FCA and Surface Water Drainage Strategy - Addendum

Date: 19 July 2023

Project No. 410.V05415.00009

**RE: Kronospan Lorry Park and Access Road
Revised Design and Stakeholder Response to Flood Consequence
Assessment**

Appendix A: Surface Water Drainage Strategy Plan

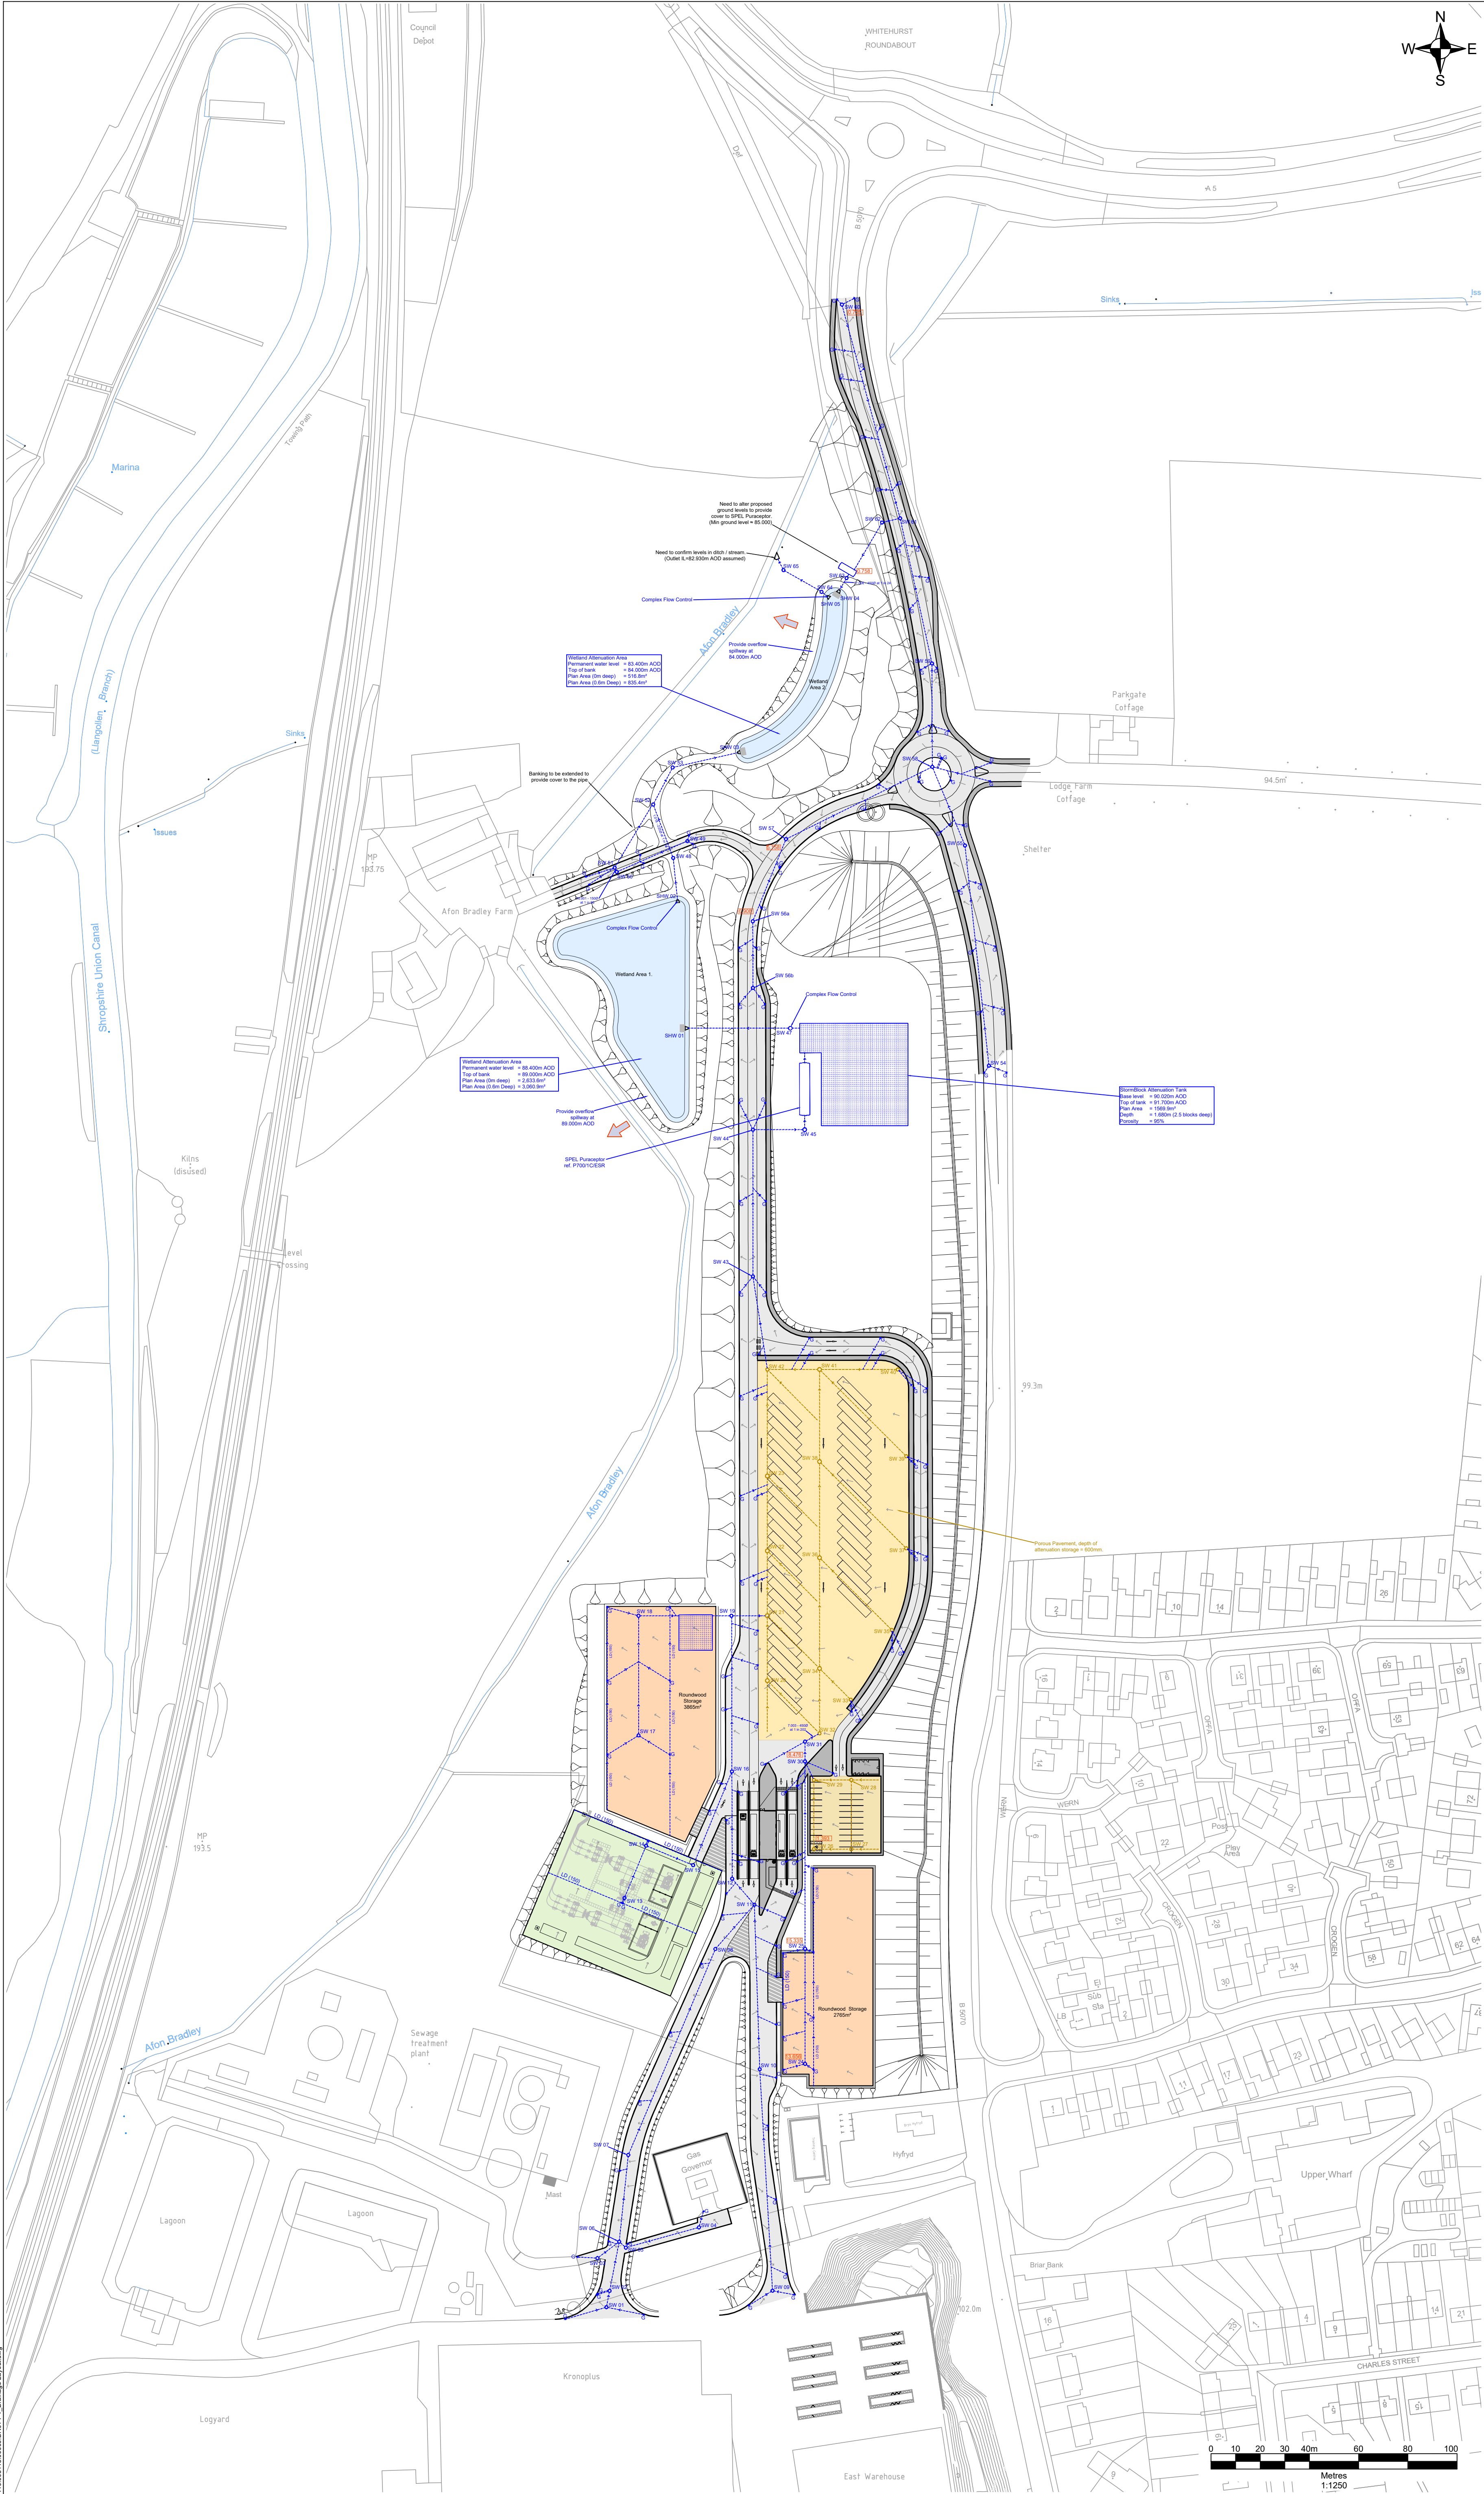
NRW have raised concerns over the potential for blockage of this piped drainage connection between the two wetland areas and the potential for this to affect downgradient areas such as Afon Bradley Farm. The revised drainage design includes a designated high level overflow point from the southern wetland area along the western embankment, adjacent to the Afon Bradley. This overflow will ensure any blockage of flows at the culvert to the northern wetland would route into the river. This routing mimics existing local hydrology and will not increase flood risk off site, including at the Afon Bradley Farm.

Concern was raised by NRW over the potential for water quality impact on environmentally sensitive areas downstream of the site. These comments were received in response to an earlier iteration of the drainage design. Further detail has since been added to the surface water drainage strategy including details of oil interceptors, penstock controls and inclusion of the roundwood storage area within the overall drainage strategy. These details will address the points raised with regard to pollution prevention.

A revision to the surface water drainage strategy has been prepared to reflect the reduction in area for the lorry park. It should be noted that there has been no reduction in the proposed attenuation within the surface water drainage strategy and as such the design is considered conservative with regard to the control of runoff volumes. A copy of the revised surface water drainage strategy plan is included at Appendix A.

The surface water drainage strategy will be subject to a separate SuDS Approval Body (SAB) application with Wrexham Council. This process will ensure the relevant criteria are met for the proposed drainage strategy with regard to control of runoff volumes and water quality.
